H.D. Cooke Modernization: Questions, Concerns and Recommendations

District of Columbia Public Schools
Henry D. Cooke Elementary School

B) Scheme B-2 Site Plan

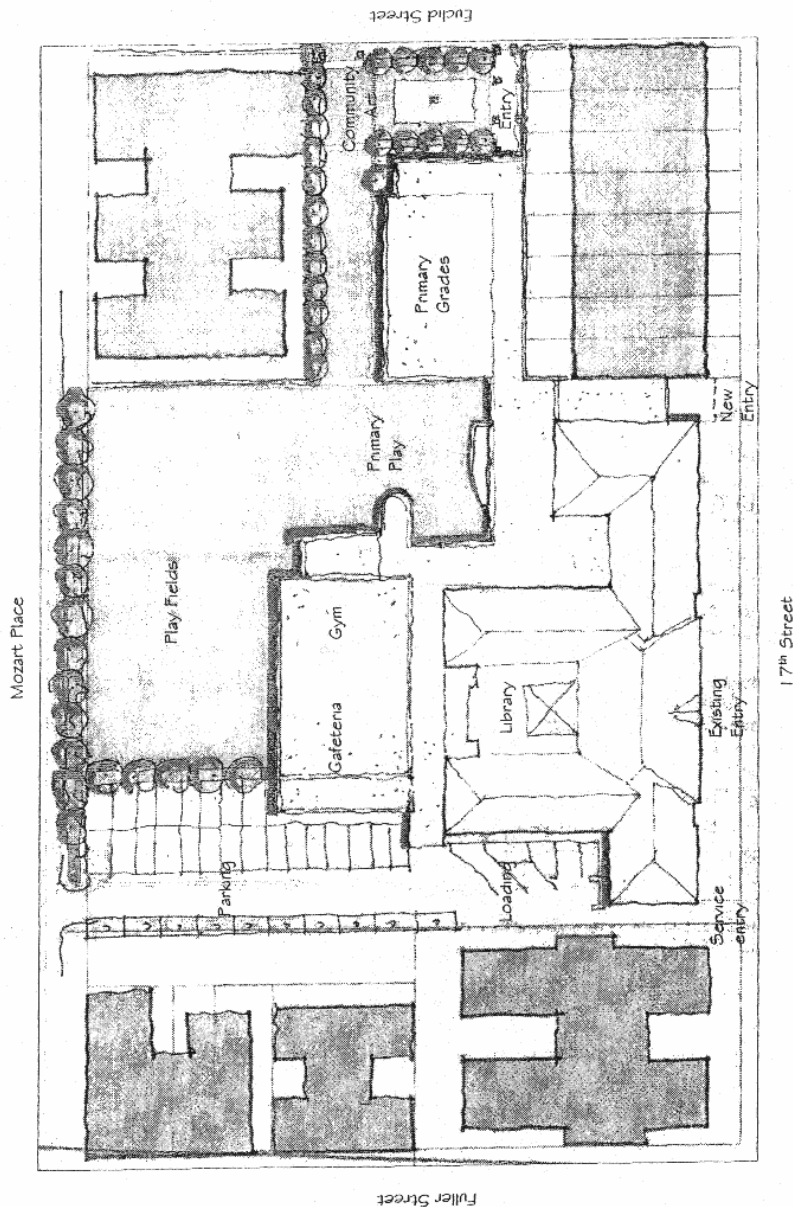
With the constraints of Cooke's odd, T-shaped site, keeping the multipurpose space as one massive footprint means it has to be located on the largest available space, necessarily taking up a good portion of what would otherwise be playground. Dividing the room's functions into two or three component parts and distributing those rooms elsewhere in the building would save playground and parking space on Cooke's peculiar site. (See attachments B and C and D.)

Building two large (although connected) additions to the school, one on the Euclid St. lot (the primary classrooms) and another at the back of the school (the large multipurpose space) requires two major foundations, roofs, etc., which contribute more to the expense than would a smaller, simpler construction area. A single addition on the Euclid Street side with a less extensive attachment to the historic school might make more sense. (See attachments B and C.)

The Option B plans appear to depend on expanses of atrium-type roofs over the “interior street” planned to connect the historic school to the multipurpose space and the primary wing. While this provides a dramatic solution to linking three buildings into one, providing great circulation, and some indirect day-lighting to the buildings connected, it creates real problems in terms of initial cost, as well as heating and cooling costs, cleaning costs, and all too soon, maintenance and repair costs. DCPS’s track record on maintenance over the past quarter century argues for the barest minimum when it comes to glass roofs. If smaller skylights will not suffice, a different solution entirely must be sought. A detailed and realistic accounting for the construction costs and long-term maintenance and repair costs must be carefully scrutinized before moving forward with atrium roofs, the interior street or even banks of skylights.

- 1) Review the extent of the planned construction, making every effort to condense the footprint.
- 2) Re-work the plan for the interior street with atrium-type roofs.
- 3) Provide a more detailed estimate of the entire cost of the project.

C) Option B-2 Modified: Ground Floor

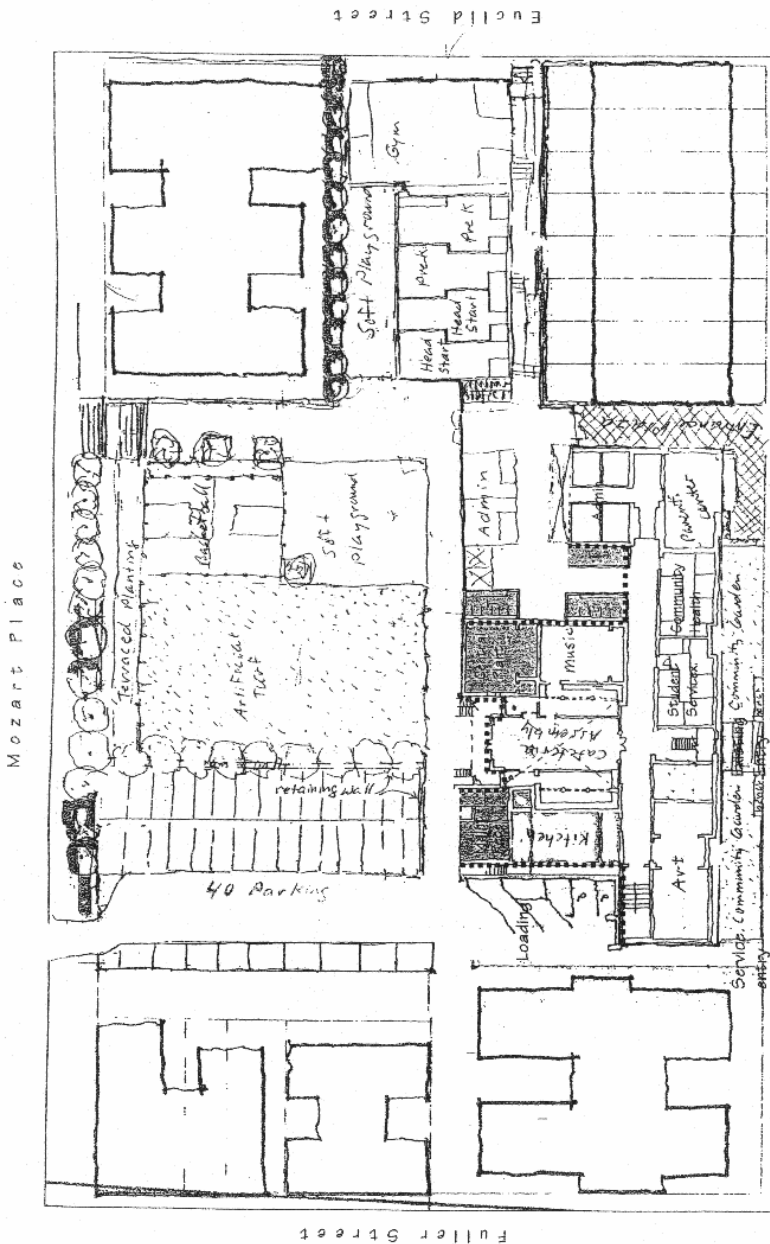
If the gym were sited at or slightly below grade on Euclid St., several problems might be solved. An active entrance to the school would be at sidewalk level, thus ridding the block of the “dead zone” that contributes to the lack of safety that is currently a problem along that street. Although connecting to the historic school might be awkward, such an entrance would provide easy access after regular school hours. Similarly, if the before and after care (and community use) offices were near the entrance with storefront-type windows facing the sidewalk, or if windows looked directly into the gym at eye-level, security on the block would be greatly enhanced. (See attachments C and D.)

A new front entrance could be located about fifty feet into the alley, where a Euclid St. addition would attach to the historic structure. Although this places the main entrance at a distance from the sidewalk, the front door would be easily seen from the street and the alley is broad enough (20 feet) to serve as an open plaza in front of the entrance. (It would be about the same distance from the front of the building as the Euclid St. entrance planned in Option B-2.) In this location, the front entrance could provide site lines into the play ground entrance and the Euclid street entrance and might be located adjacent to the administration area. The plaza area could be a useful gathering place before school. Good lighting would be crucial. (See attachment C.)

- 1) Separate the gym, cafeteria and auditorium functions if possible — or plan either a gym/auditorium or a cafeteria/auditorium.
- 2) Jettison the plan for a separate lunch room for the primary grades.
- 3) Keep the present cafeteria/assembly room.
- 4) Locate the gymnasium on Euclid Street.
- 5) Locate the media center in the new construction.

- 1) Locate the Community Art garden/seating area around the historic front entrance.
- 2) Build a new entrance across the alley where the Euclid St. parcel meets the main building site.
- 3) Avoid attaching to the adjacent row house.
- 4) Locate the Euclid Street entrance near a windowed, occupied office.
- 5) Provide a pleasant door into the school from the parking lot.
